राष्ट्रीय कोशिका विज्ञान केंद्र
NATIONAL CENTRE FOR CELL SCIENCE
 (An Autonomous Institution of the Department of Biotechnology, Govt. of India)
 Savitribai Phule Pune University Campus, Ganeshkhind, Pune- 411007

MINUTES OF PRE-BID MEETING FOR SITC, QUALIFICATION AND VALIDATION OF c-GMP COMPLIANT MAMMALIAN CELL LINE REPOSITORY ON TURNKEY BASIS AT NCCS JIDNYASA BUILDING, KOTHRUD, PUNE

Tender Ref No. : NCCS/MAINT/GMP/454C/2023-24; dt-01/11/2023.
Date : 10/11/2023 @ 14:30 Hrs
Venue : Board Room 'A' Building.

SCHEMATIC REPRESENTATION OF 3 PIPE VRF SYSTEM

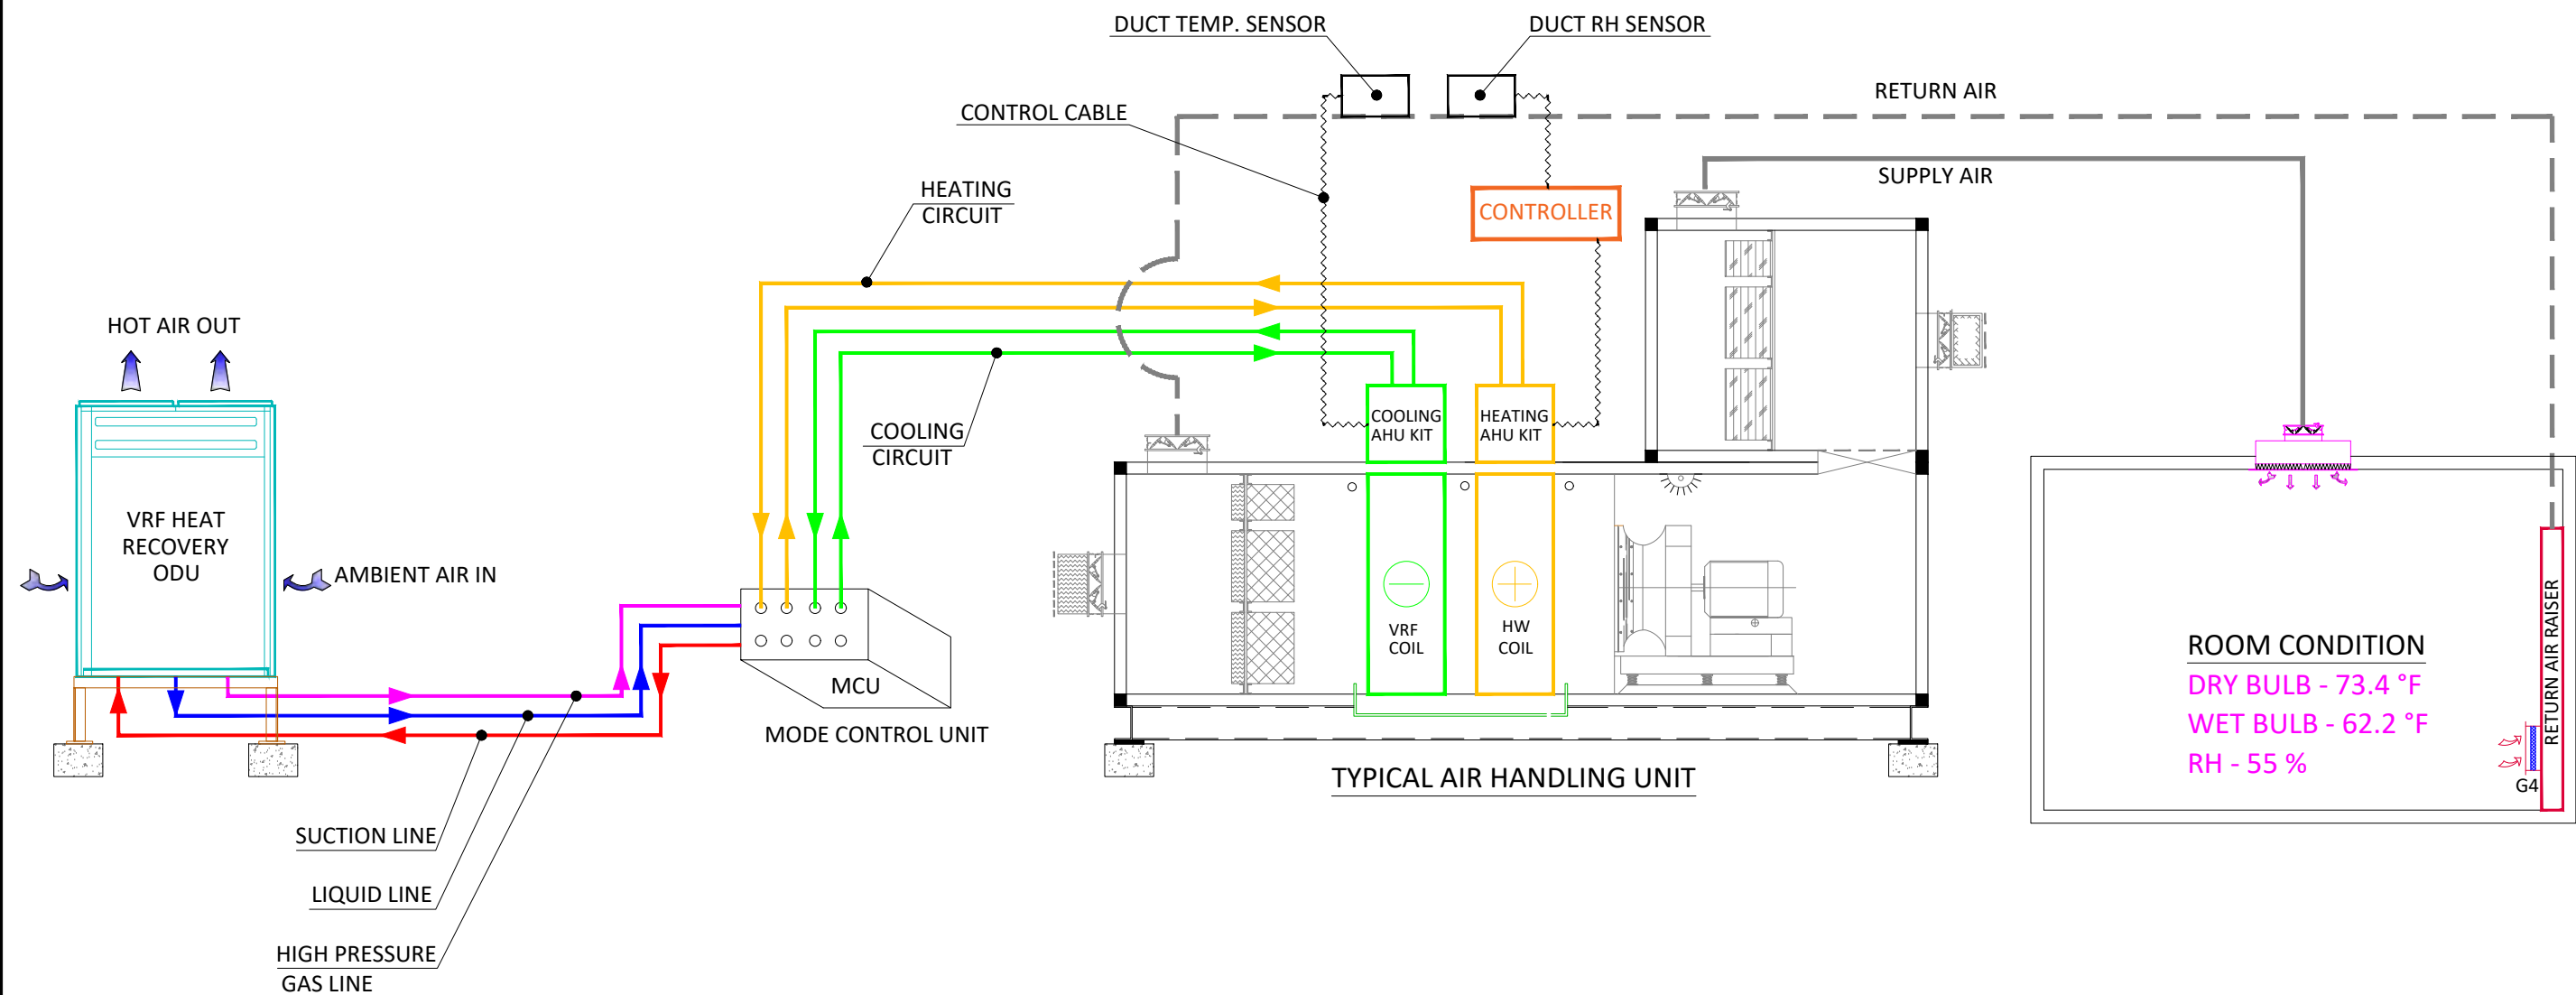
How with common header is controlling going to work in ref piping, can we have different ODU for each AHU. Because the load will be variable.	Refer the tender specification, PID & Schematic representation with working philosophy. AHU kit (Expansion & communication) is considered based on the AHU capacity as this will control the flow of refrigerant based on the requirement.
		Redundancy needed for BMS.	Follow the tender specification
		Pls explain IO summary and control logic for VRV system. And philosophy of operation.	Refer IO summary sheet in the tender document.
		Cooling Coil selection and heating coil selection? How to do. CFM/TR for both cooling coil and heating coil any limitations. Pls elaborate.	Follow the tender specification & drawings
22	Tech Bid, PART 11 (1) – COLD ROOMS	Bidder requested to consider brand of POLFROST for the same.	NCCS did not agree for the same and suggested the bidders to follow the tender makes only.
